Subject: Submittal of the Response to the Notice of Disapproval for the Investigation Work Plan for Upper Sandia Canyon Aggregate Area and Revision 1

Cross-Reference of NMED NOD Comments and Revisions to Upper Sandia Investigation Work Plan

Figure 4.1-56 Map P site location

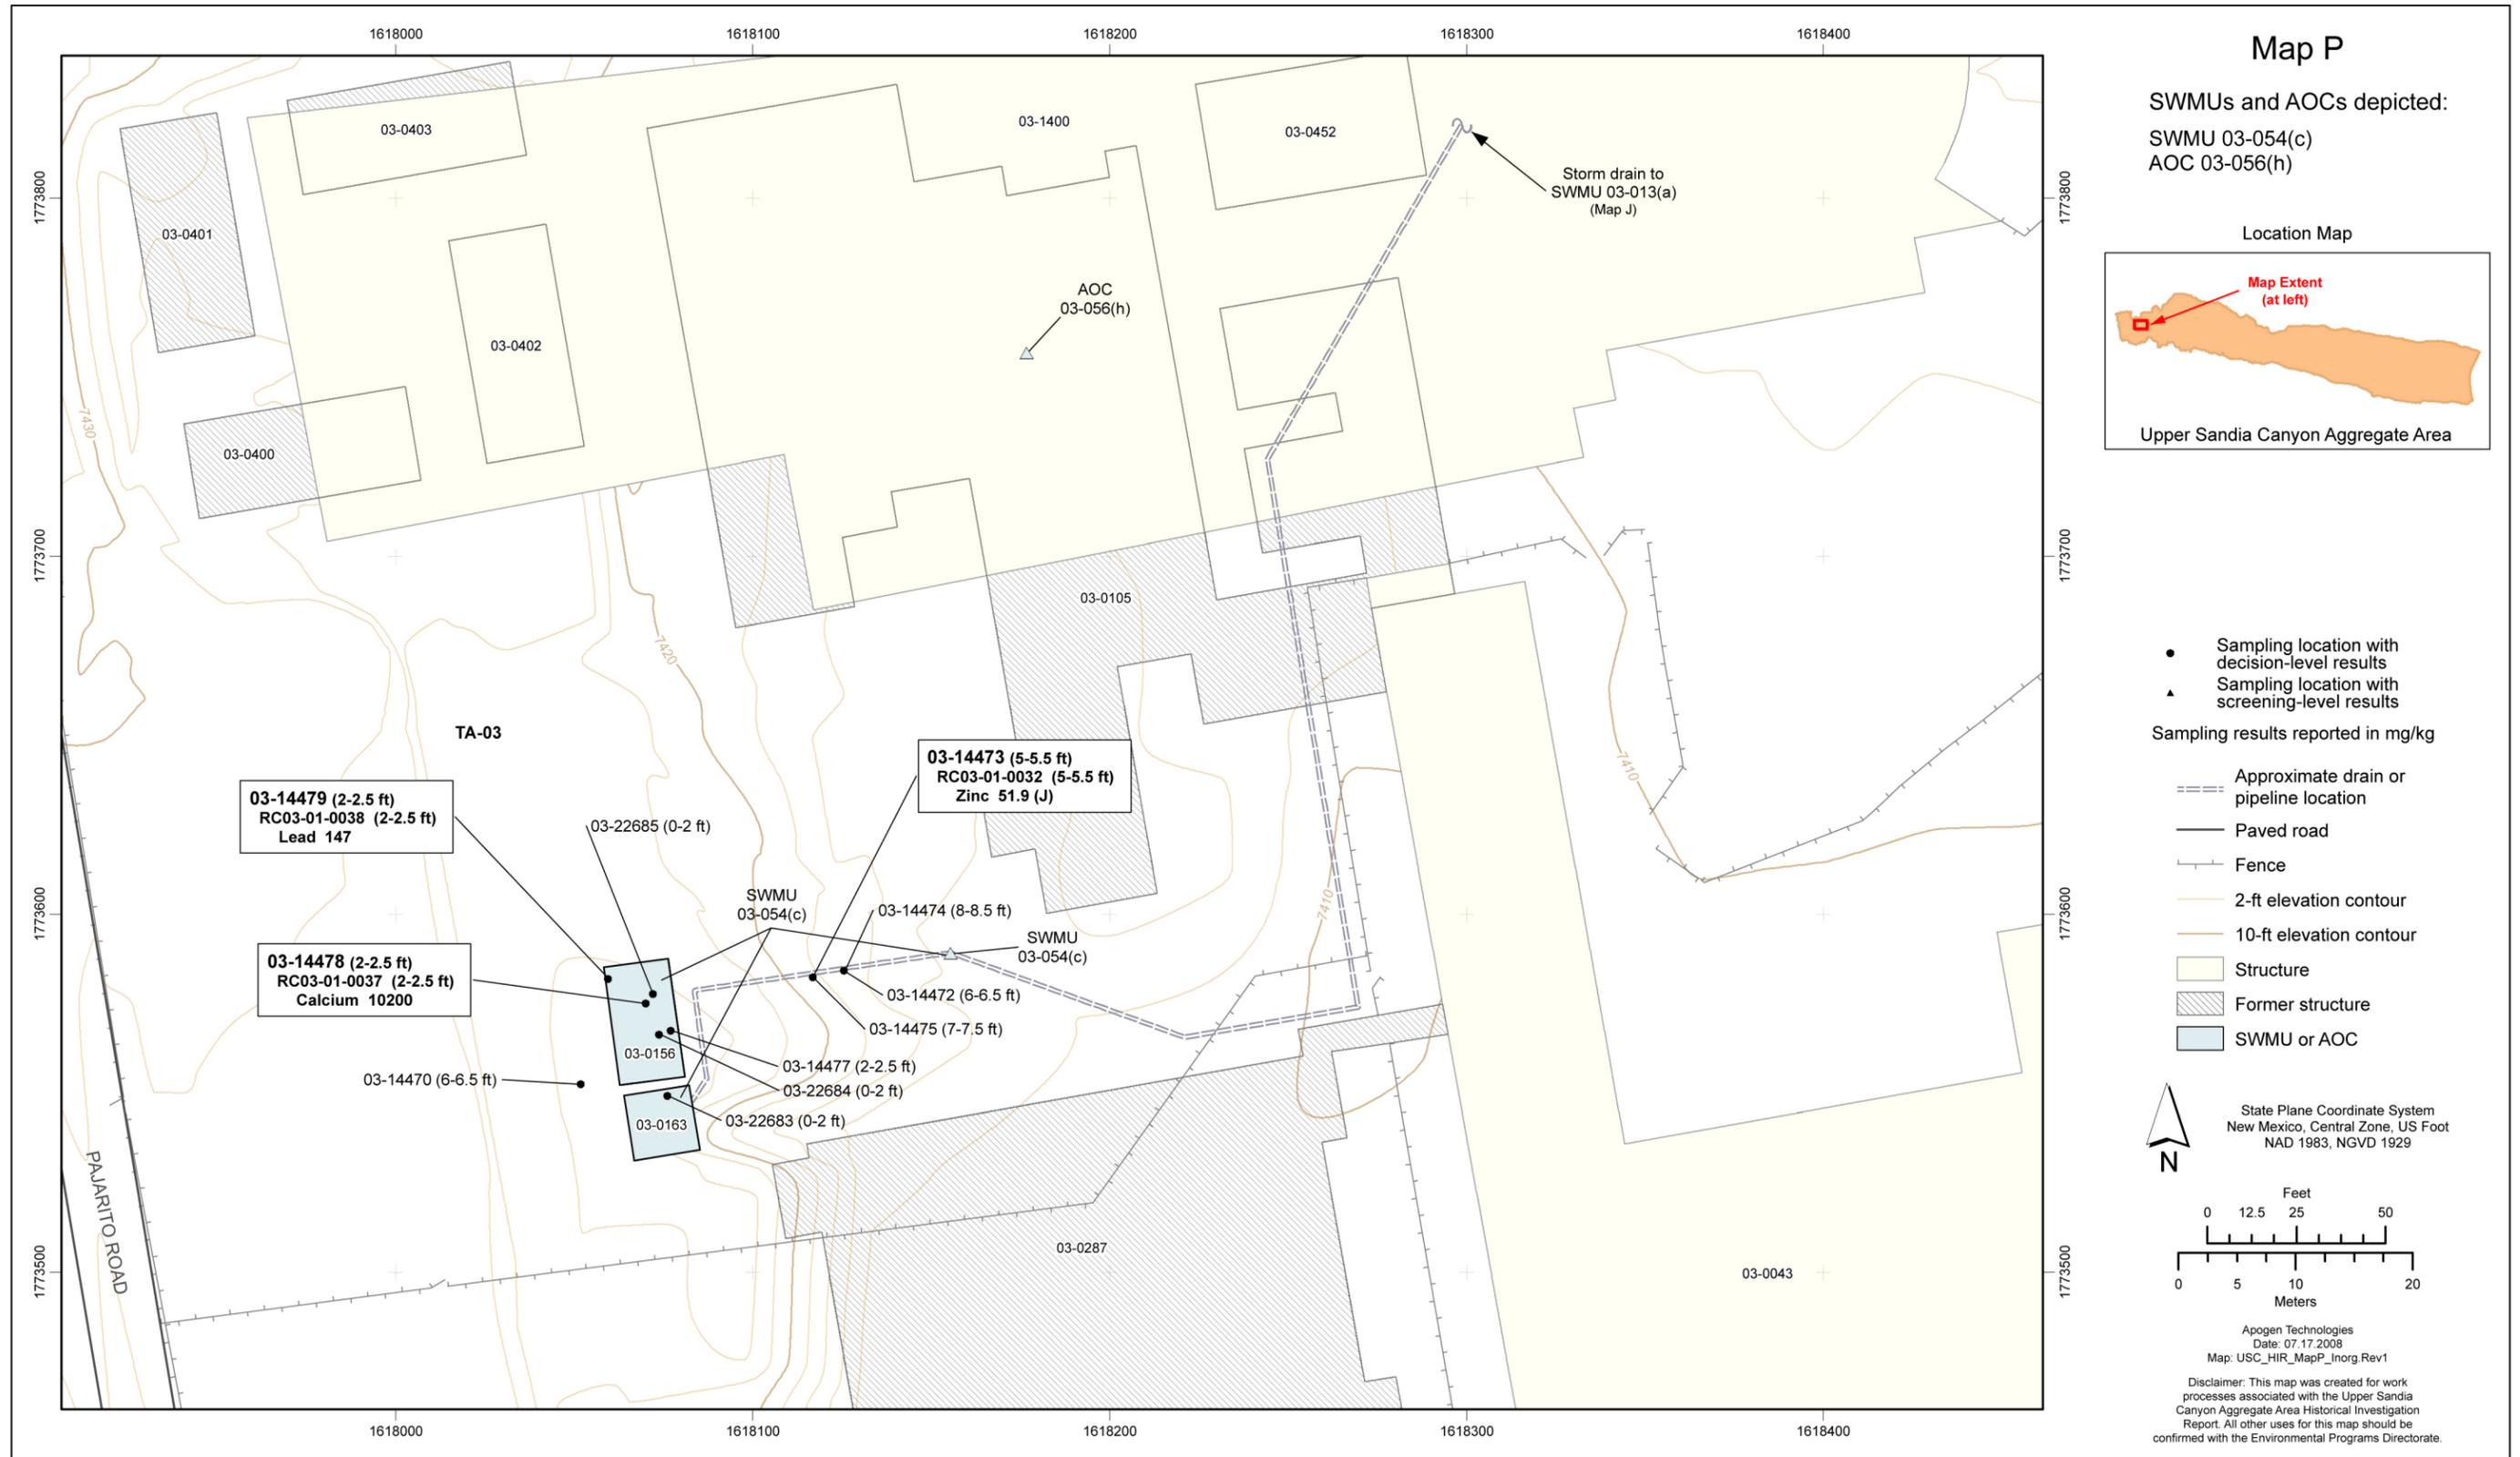
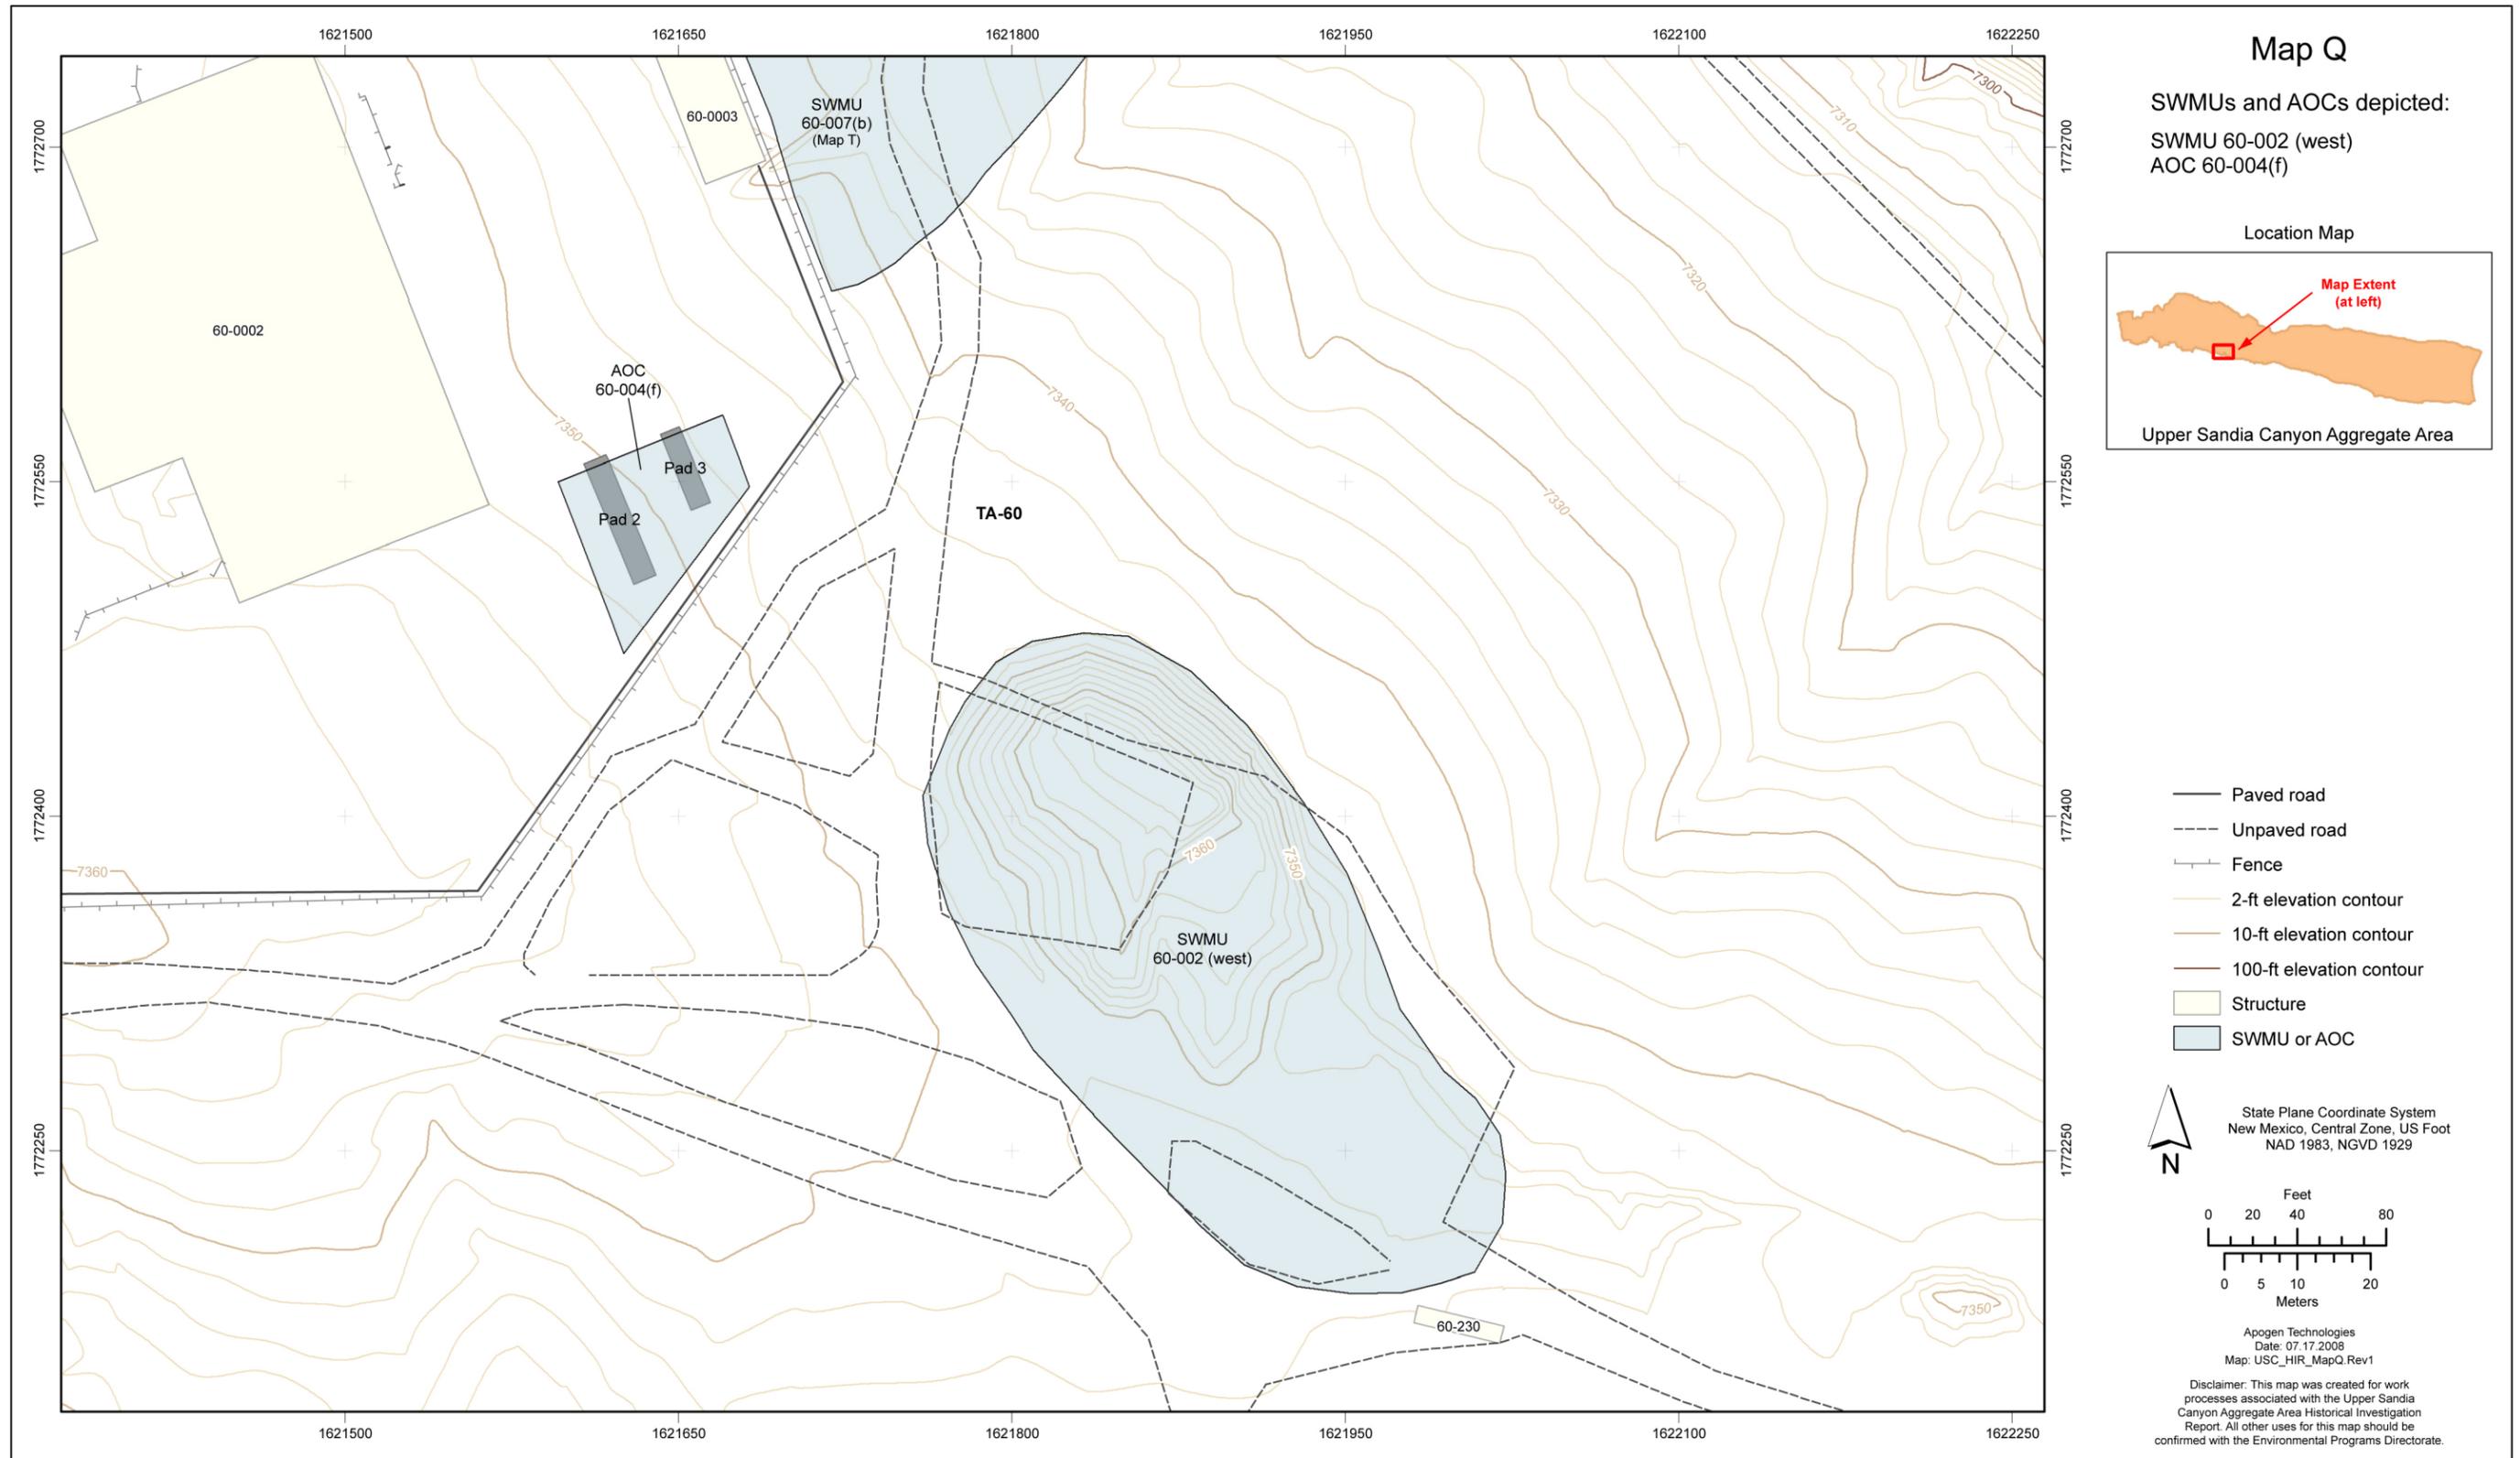
6. *The Permittees have not depicted boundaries for some SWMUs on the figures. The sites are denoted by a small triangle on the figure, but the 'Site Description' describes much larger areas as SWMUs. For example, Figure 4.1-56 depicts SWMU 03-054(c) as a small triangle, but Section 4.1.38 describes structures 03-0156 and 03-0163 and an outfall as part of SWMU 03-054(c). Without the SWMU boundary depicted on the figure it is difficult to determine if proposed sampling locations are adequate to define the nature and extent of contamination. Figures must be revised to depict the boundaries of the entire SWMUs/AOCs.*

The SWMU is described as a former cooling tower, pump house and outfall, but is depicted on the Figure 4.1-57 by a small triangle. The boundary for the entire SWMU must be depicted on the figure. Since the locations of samples that were collected in 2004 are not depicted on the figure, it is not clear if any samples were collected at or near the outfall. Samples must be collected at the outfall location to define the nature and extent of contamination. Drainage from the outfall must be clearly indicated on the figure and sampled. The Permittees must collect samples along the entire length of the drainage to the toe of the colluvium (see General Comment # 3).

28. Figures 4.1-56 and 4.1-57 have been revised to include the drainlines leading from SWMU 03-054(c). The areas occupied by former structures 03-0156 and 03-0163 have also been added as part of the SWMU 03-054(c) boundary. Section 4.1.38 has been revised to describe subsequent removal activities and confirmation sampling conducted at the site prior to the construction of the new National Security Sciences Building (NSSB) (building 03-1400).
